City of Portland, Maine – Building or Use Permit Application 389 Congress Street, 04101, Tel: (207) 874-8703, FAX: 874-8716

REASON FOR PERMIT: Single Family dwelling with attached garage

**CITY OF PORTLAND, ME
BOCA 1990 Plan Review Record
One and Two Family Dwelling**

Building Description: Single Family dwelling with attached garage.

FRONT ELEVATION
SCALE 1/4"=1'-0"

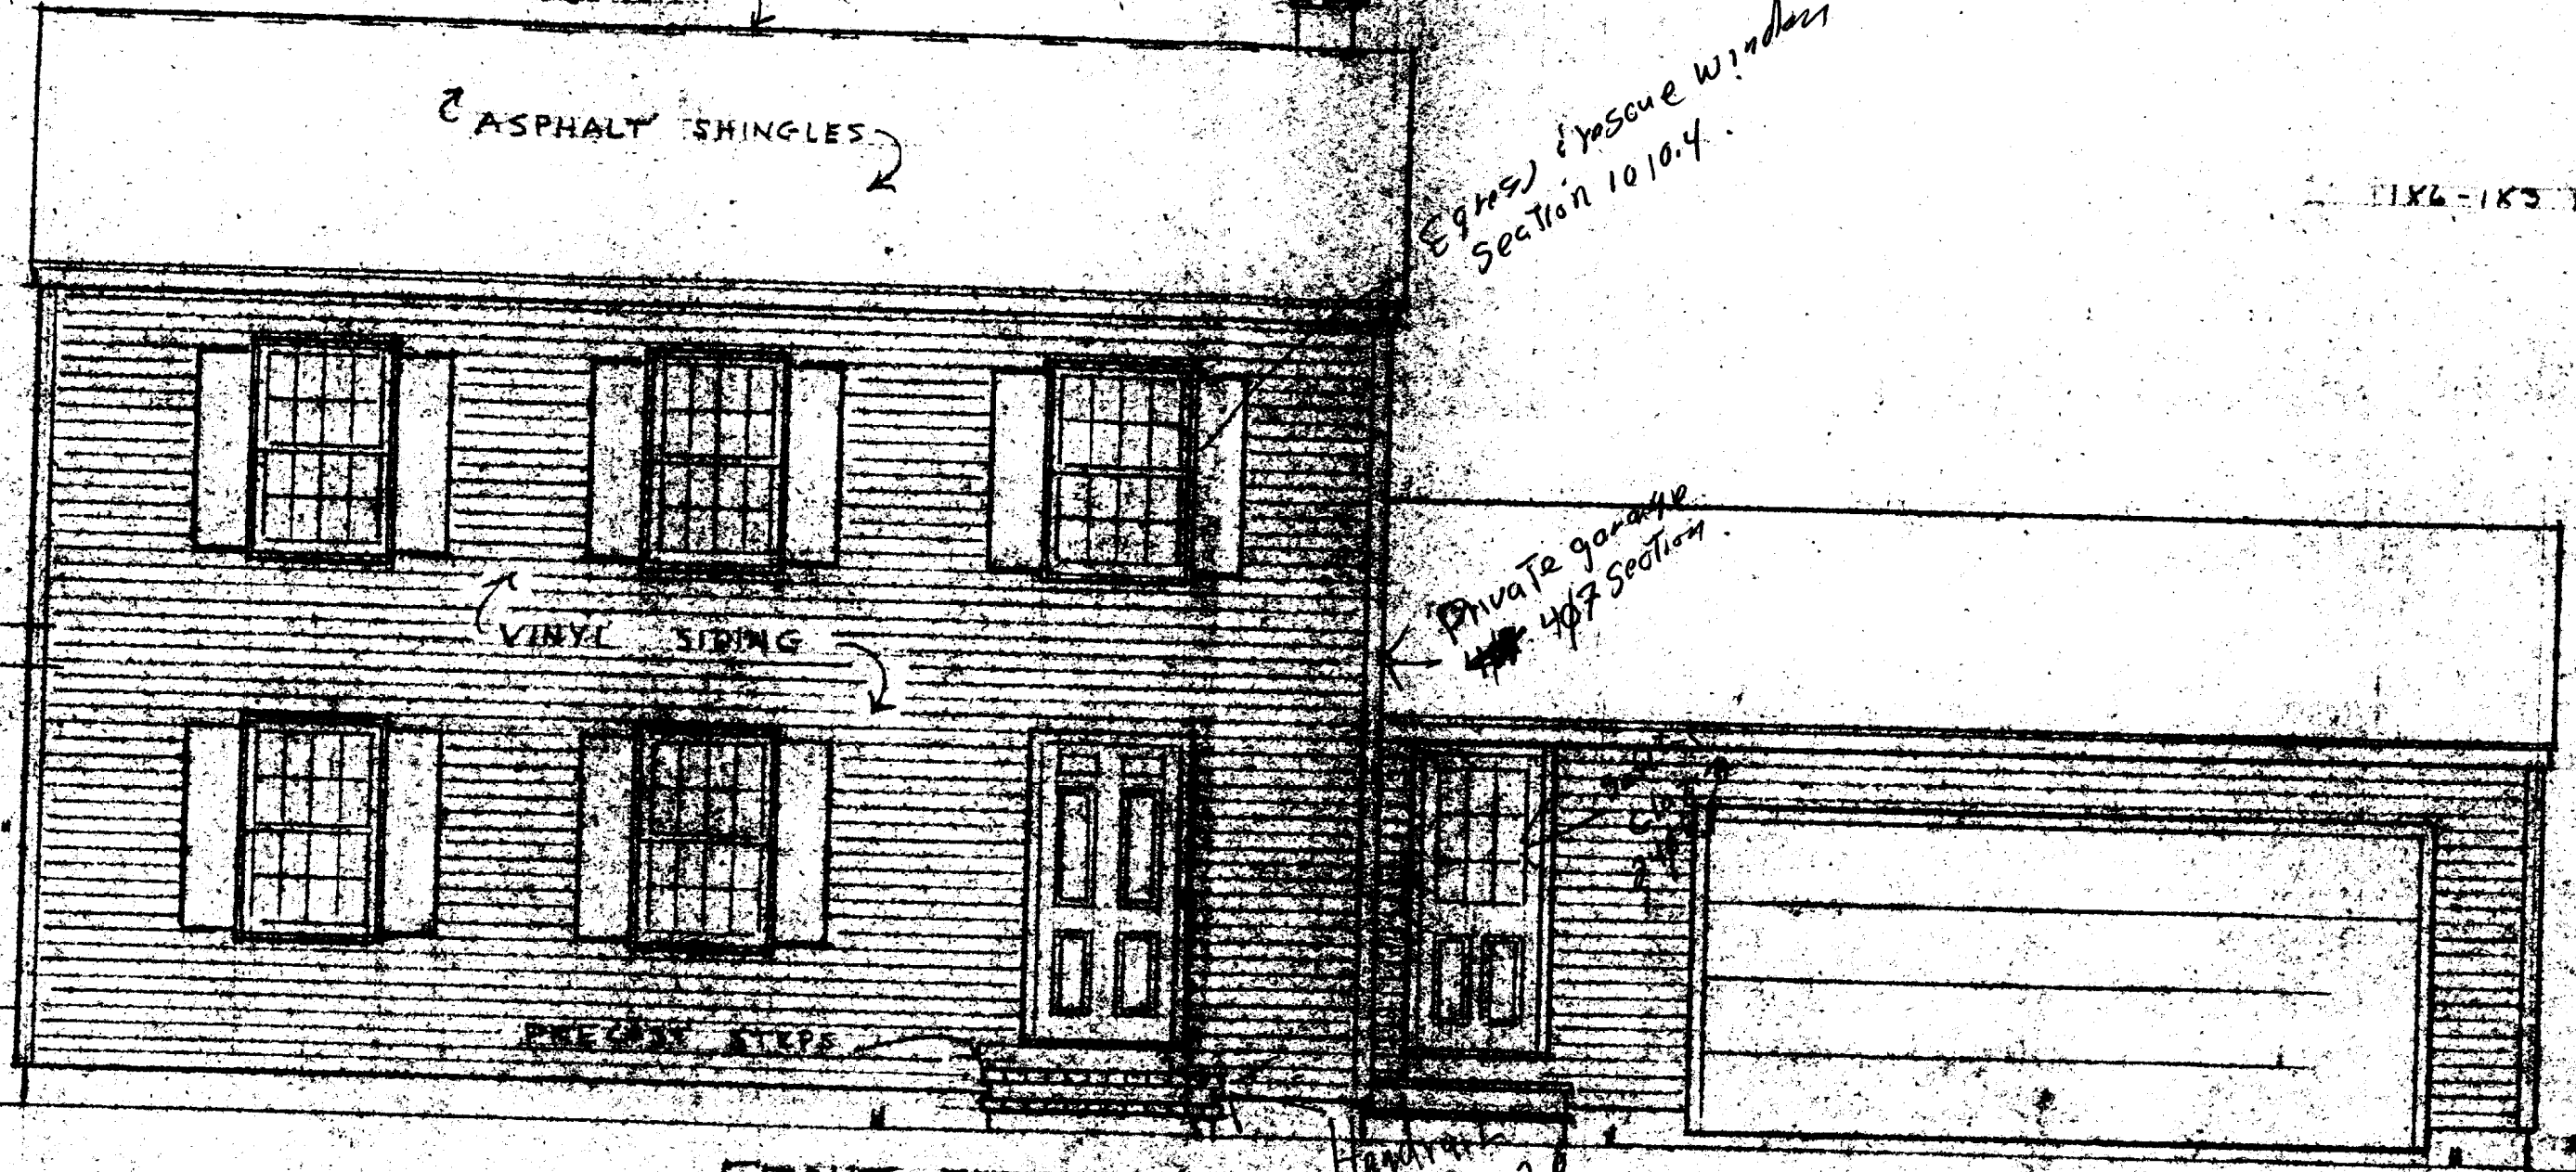
Eggs) escape window
Section 1010.4

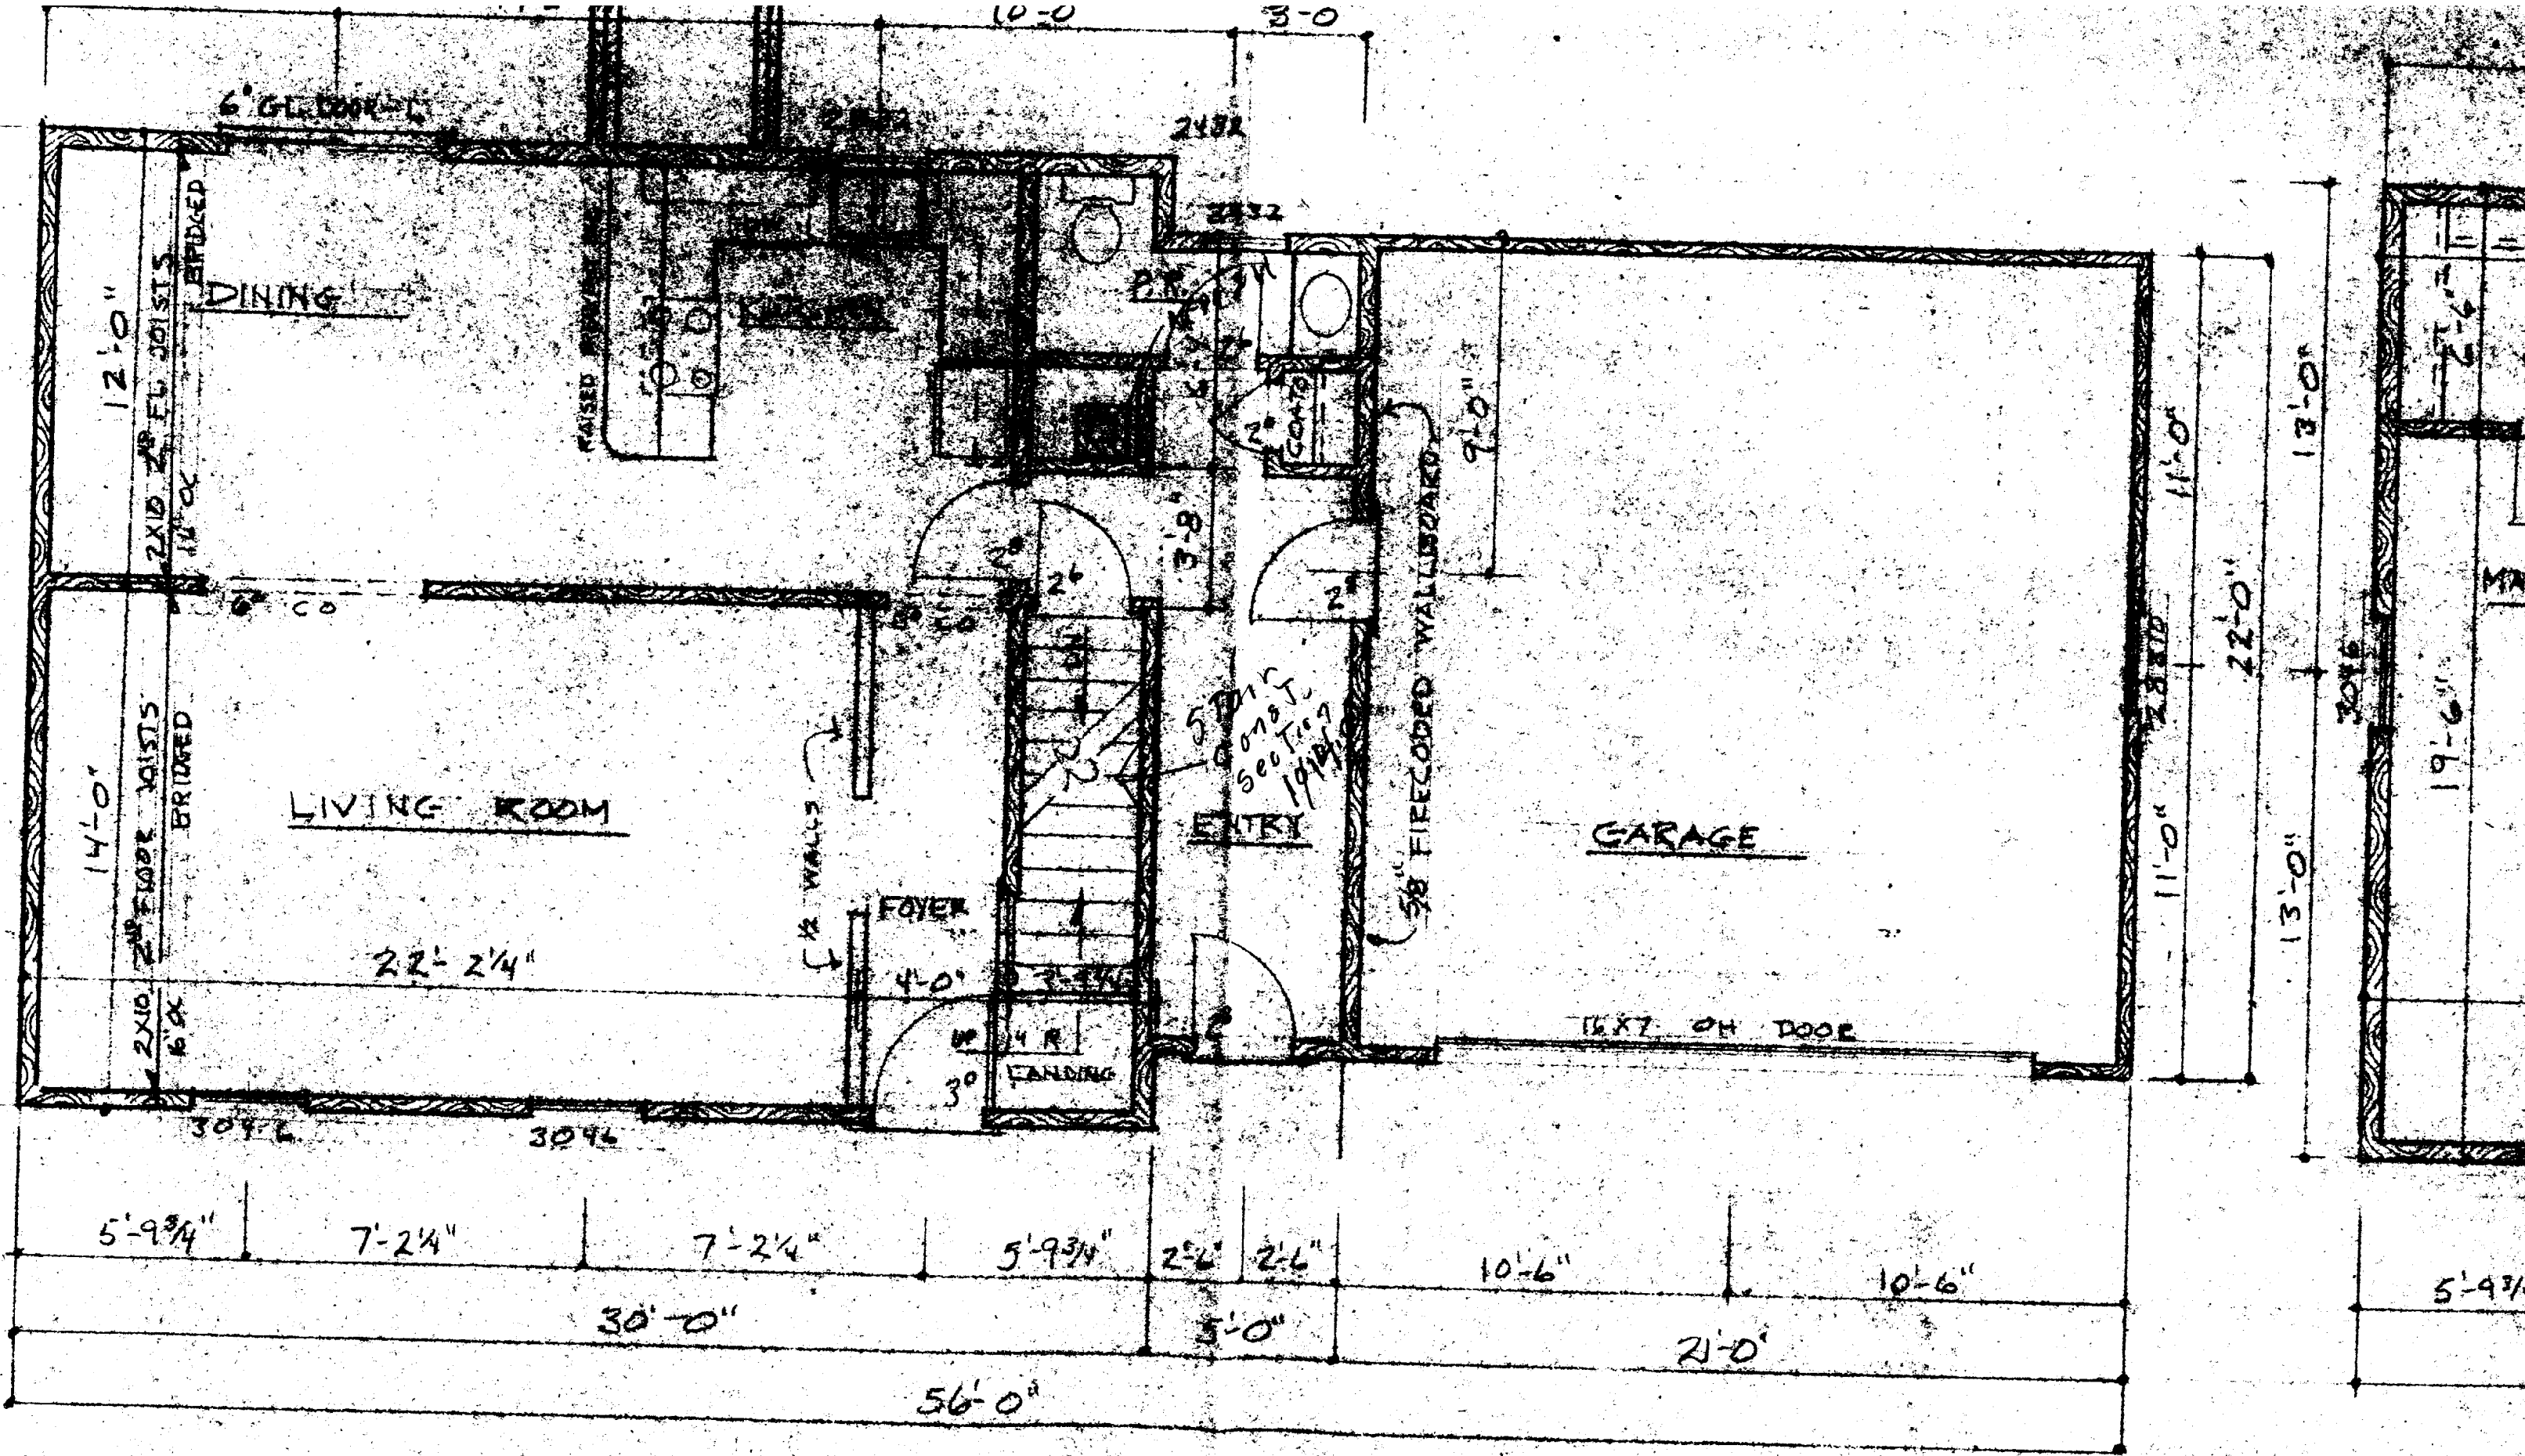
Private garage
407 Section
